Watts Bar Nuclear Plant, Unit 2
NRC Docket No. 50-391

Subject: Watts Bar Nuclear Plant (WBN) Unit 2 – Submittal of Developmental Revision G of the Unit 2 Technical Specification (TS) and Technical Specification Bases

WBN Unit 2 TS and TS Bases Developmental Revision G Mark-ups

FIGURE 4.3-4
MINIMUM REQUIRED BURNUP FOR ~~A 2X2~~ CHECKERBOARD ARRANGEMENT OF
2 SPENT ~~AND FUEL ASSEMBLIES WITH~~ 2 NEW FUEL ASSEMBLIES OF 5% ENRICHMENT
(MAXIMUM)

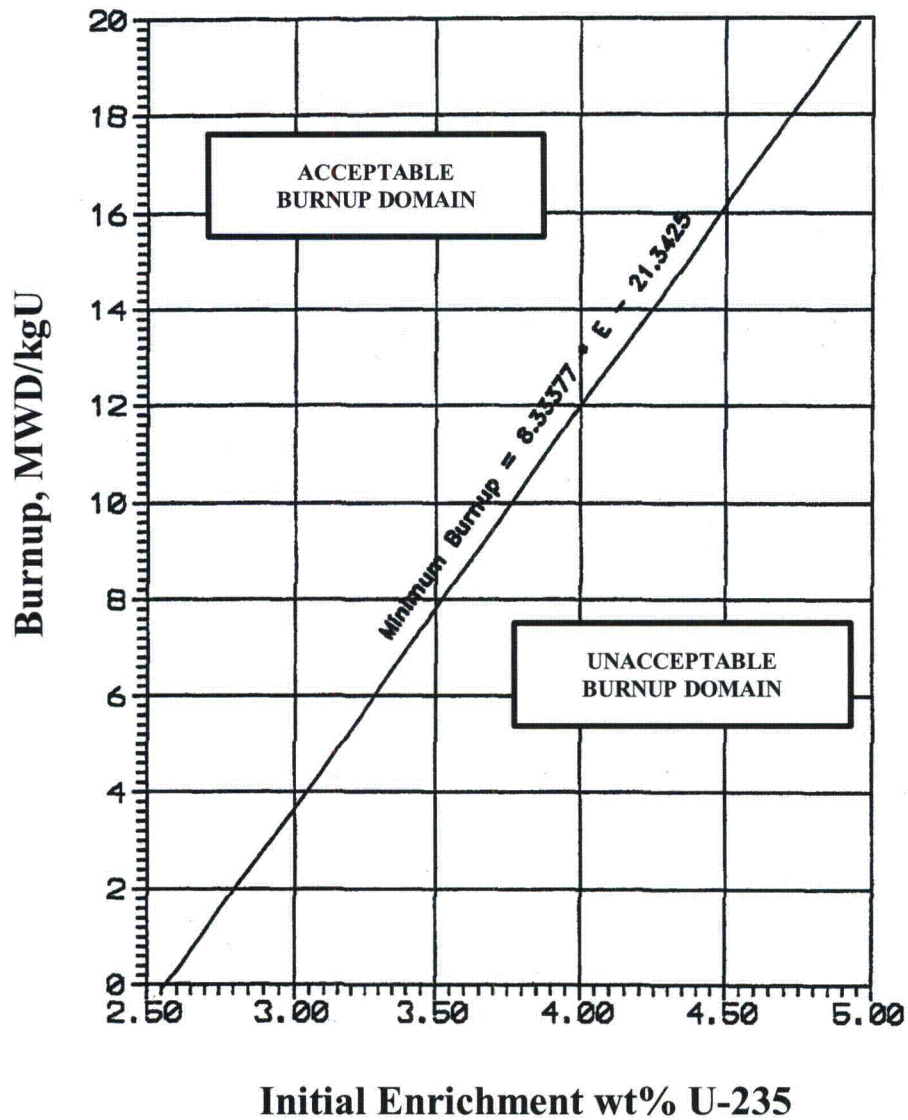
- Change to TS Bases B 3.8.4 on DC Sources to update the number of battery chargers needed for two-unit operation and to match current Unit 1 wording.
- Change to TS 4.3.1, Criticality describing acceptable spent fuel pool loading patterns.

2. New and spent fuel assemblies may be stored in a checkerboard arrangement of 2 new and 2 spent assemblies, provided that each spent fuel assembly has accumulated a minimum burnup in the acceptable domain identified in Figure 4.3-4.
